Accessibility Compliance

PROJECT NAME: New Maitland Hospital – State Significant Infrastructure Stage 2 Access Report

DATE: 26 March 2019

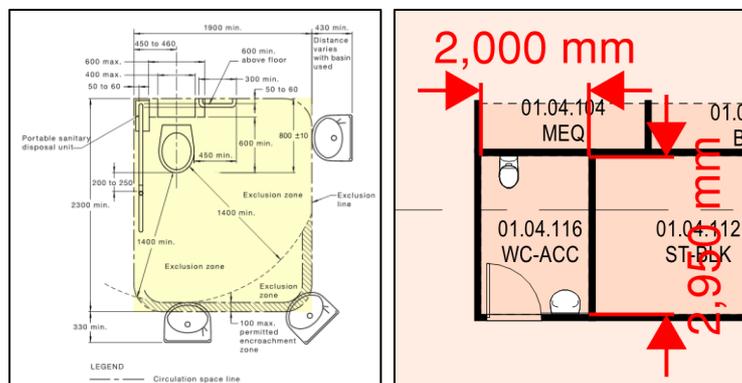
The number and location of the proposed accessible toilets are at this stage generally consistent with the BCA/DDA Access Code, however is noted that the BCA Assessment of Occupant Numbers vs. Sanitary Facilities has not yet been completed (Refer Table 2 Item H from BCA Report Rec C) and this may influence overall toilet provisions.

Refer to the work in progress (WIP) discussion documents between BVN and Group DLA (GDLA / BVN discussion comments dated 10.01.2019 and BVN SK174_190221_DDA Meeting Mark-up).

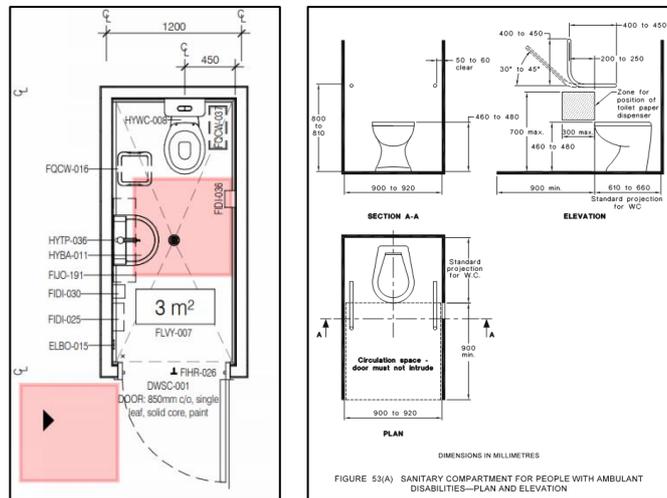
The accessible bathrooms are to have a balance between transfer side (ie. left / right handed) with internal dimensions to cater for min. AS1428.1 circulation spaces for and between all fixtures. Generally, an accessible bathroom with 2350mm W x 2750mm min. L will allow fixtures installation in compliance with AS1428.1 Fig 43 and 50 as shown below:

During design development stage, the detailed design and fit-out of the unisex accessible toilets, including circulation areas between fixtures and fixtures/fittings will be developed and documented to confirm required access features for people with disability in compliance with AS1428.1 to satisfy BCA/DDA Access code Part F2.4.
